CHARTER TOWNSHIP OF GARFIELD PLANNING COMMISSION MEETING

Charter Township of Garfield Planning Department Report No. 2022-104			
Prepared:	November 2, 2022	Pages:	5
Meeting:	November 9, 2022 Planning Commission	Attachments:	<input checked="" type="checkbox"/>
Subject:	SPR 2022-16 Birmley Hills Site Condominium – Public Hearing		
File No.	SPR 2022-16	Parcel No.	05-026-020-30
Owner:	T&R Investments, Steve Zakrajsek		
Agent:	Boyne Engineering and Design

November 1, 2022

ORIGINAL ISSUE DATE:
09/21/2022
SCALE: 1"=50'
BED JOB NO. 22016
DRAWING NUMBER
C2.0

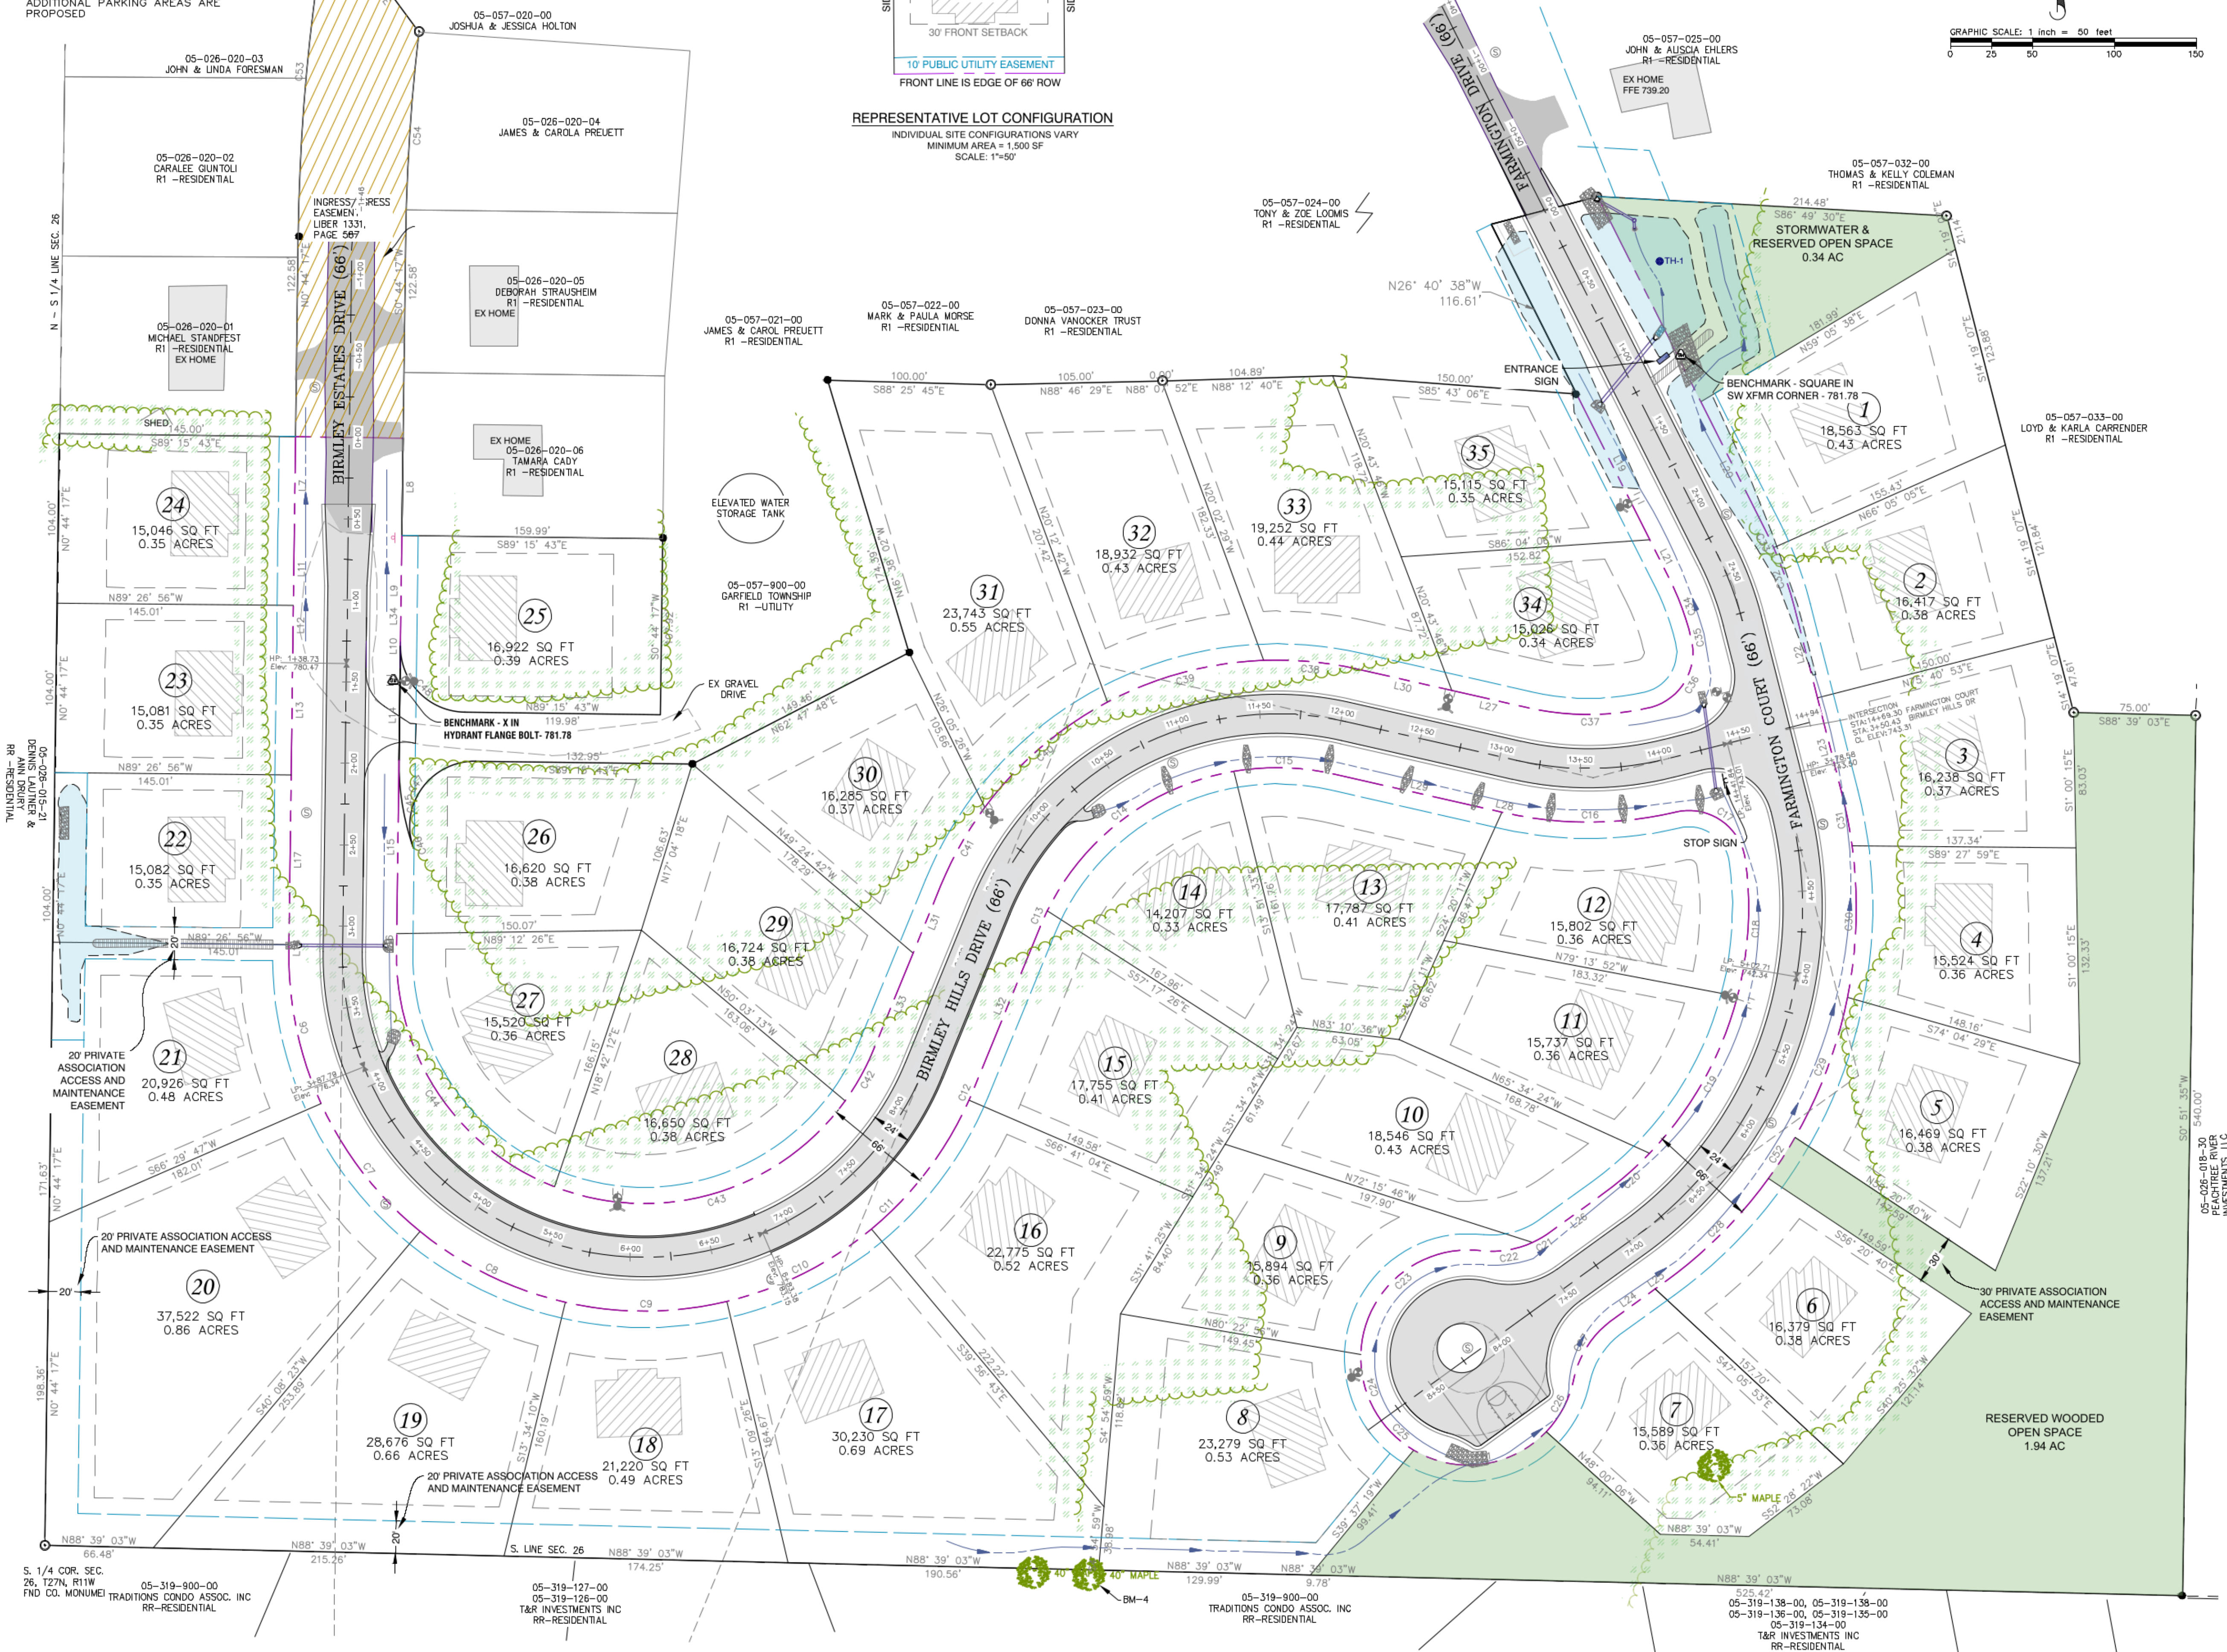
The site to the west is not subdivided and thus the proposed Birmley Hills site condominium is required to provide a street connection to the west. The adjacent parcel to the west (Parcel No. 05-026-015-21) is currently zoned as A-Agricultural but is designated Low Density Residential on the Future Land Use Map in the Master Plan. Furthermore, comments from the Township Engineer indicate that a water main stub and sanitary main stub shall be provided to the abutting western parcel. The Township Engineer’s letter dated November 1, 2022 is provided as an attachment.

The applicant is advised to prepare an updated site plan drawing with a design showing a stub for water, sewer, and street connection to the adjacent property to the west.

ORIGINAL ISSUE DATE:
09/21/2022
SCALE: 1"=50'
BED JOB NO. 22016
DRAWING NUMBER
C3.0

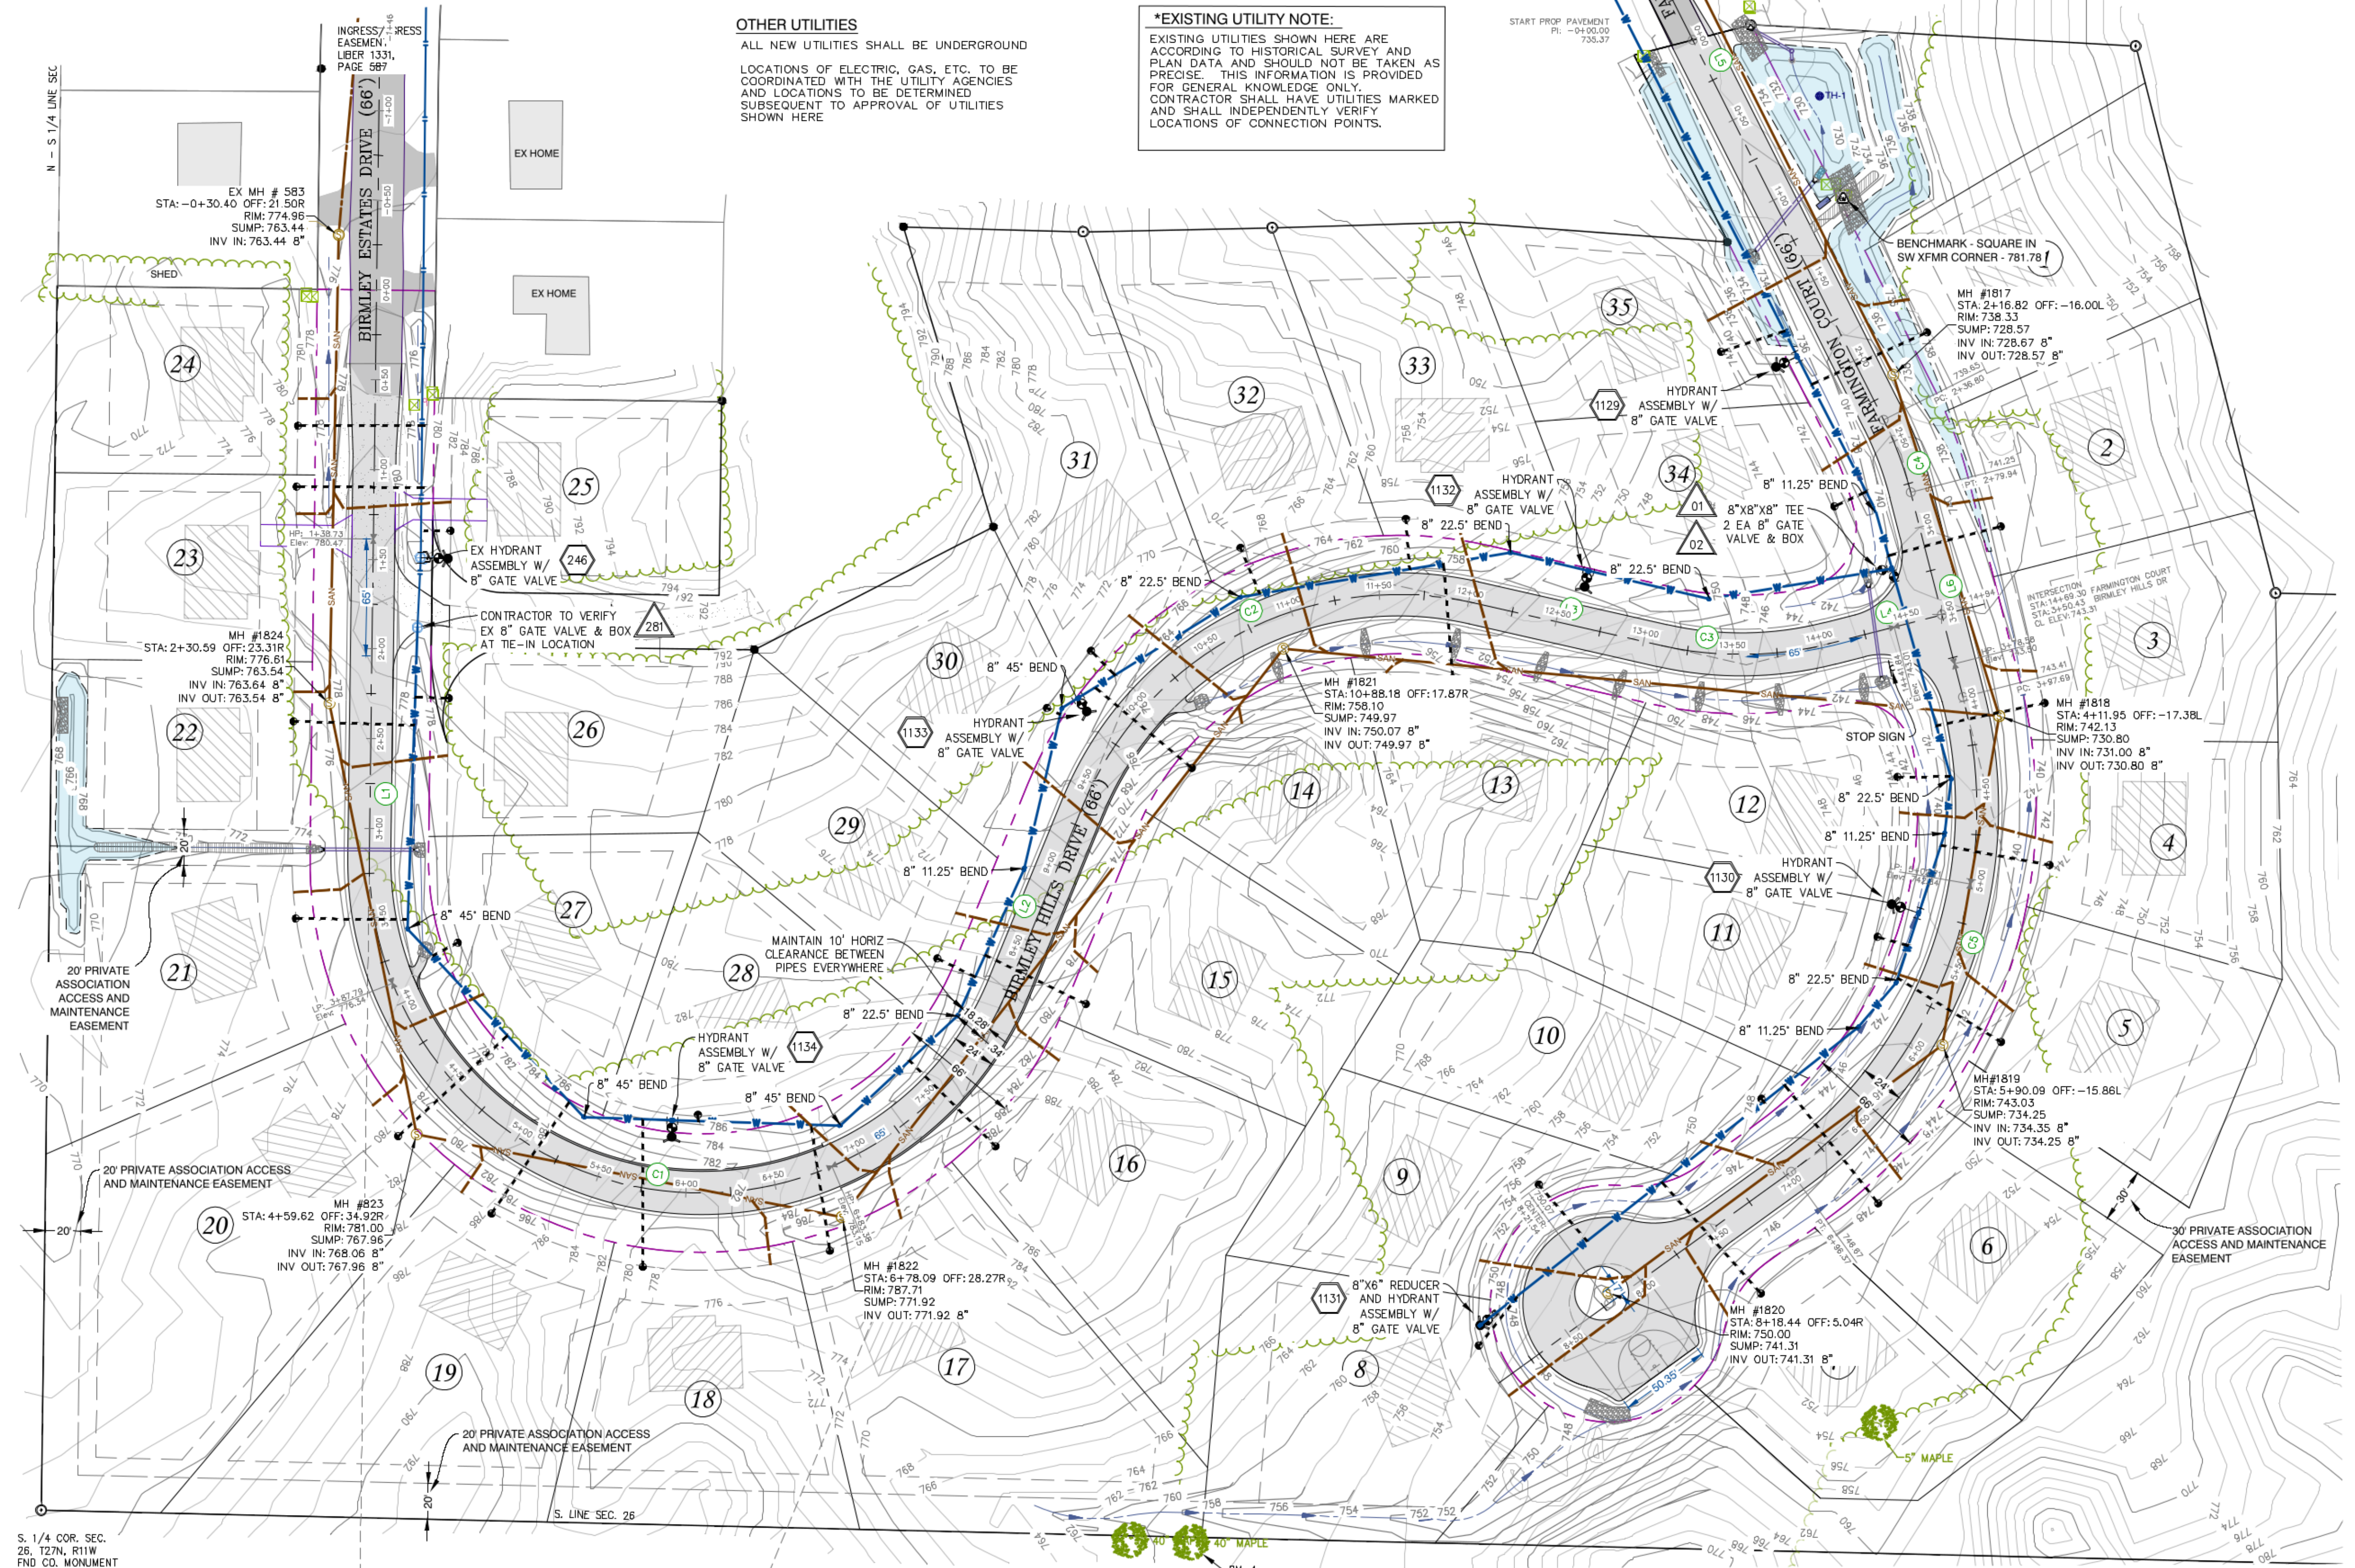
4. A sanitary main stub shall be provided to the abutting western parcel to accommodate a future access/ connection.
5. Sewer Manhole 1822 appears to have flow in two (2) directions and shall be separated into two (2) manholes and segments rather than connected to prevent backups and surcharging.
6. Manhole 1818 inverts and sump elevations do match between sheet C4.0 and C4.1
7. All manholes shall be constructed to provide 1/10 drop between in and out inverts. MH #1819 illustrates both as the same.
